**ITEM**                      **Section 96(2) Modification Application reported to the Sydney West Joint Regional Planning Panel (JRPP) for determination in accordance with Part 4 (Regional Development) of State Environmental Planning Policy (State and Regional Development) 2011**

**FILE**                      **DA-821/2012/1 - East Ward**

**JRPP Reference: 2014SYW013**

### **DA-821/2012/1 for 351 Hume Highway, Bankstown**

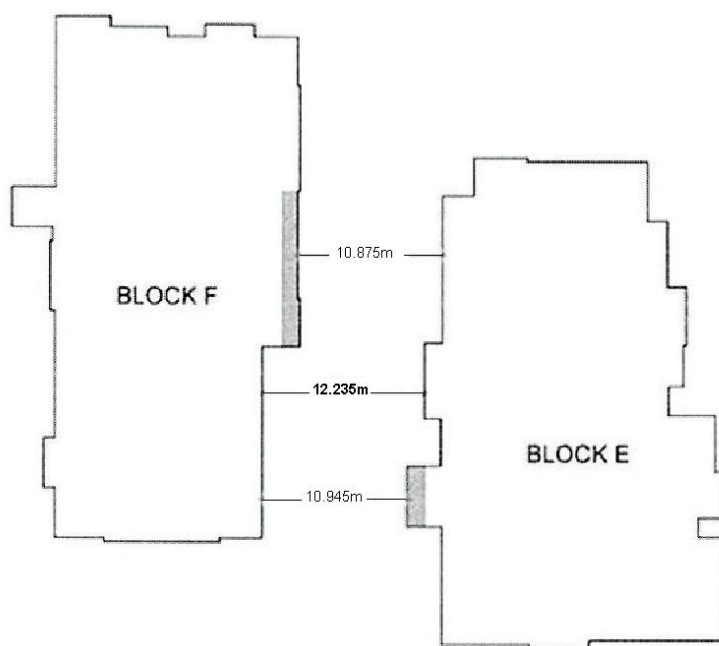
Generally, the subject application as modified provides sufficient separation between buildings. The Residential Flat Design Code recommends a minimum dimension or distance of 12m between habitable room/balconies for buildings up to 4 storeys. However, the development as modified does not provide the minimum 12m between Blocks E and F as shown in the figure below.

The internal encroachments mentioned above are considered minor as they represent a shortfall of around 9% of the recommended 12m. As the development otherwise provides 12m, overall the development is considered to provide adequate spatial relief between the buildings to allow for sufficient visual and acoustic privacy.
